UNITED STATES PATENT AND TRADEMARK OFFICE

10/761,975

Office Action Summary

Fig. 5

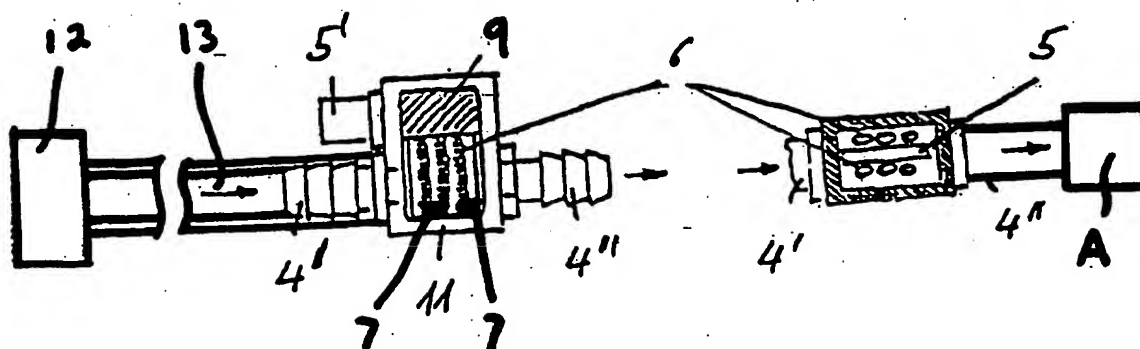
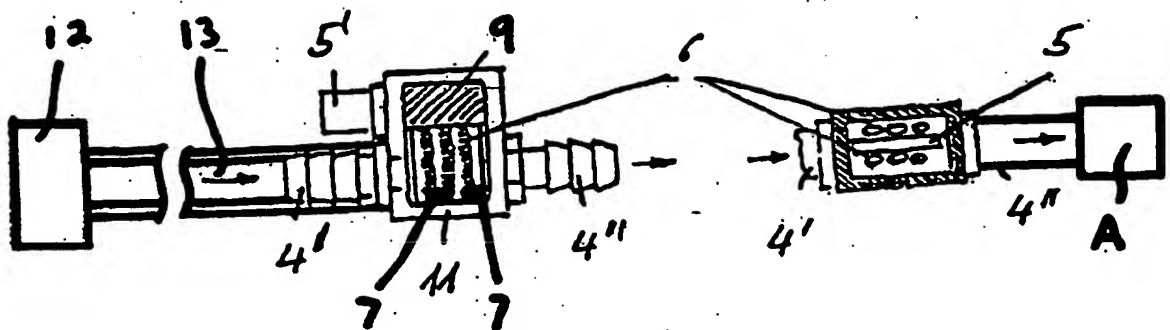
Applicant is reminded of the election of species D figure 5 in paper filed 11/23/05. The claims are no longer generic as previously argued.
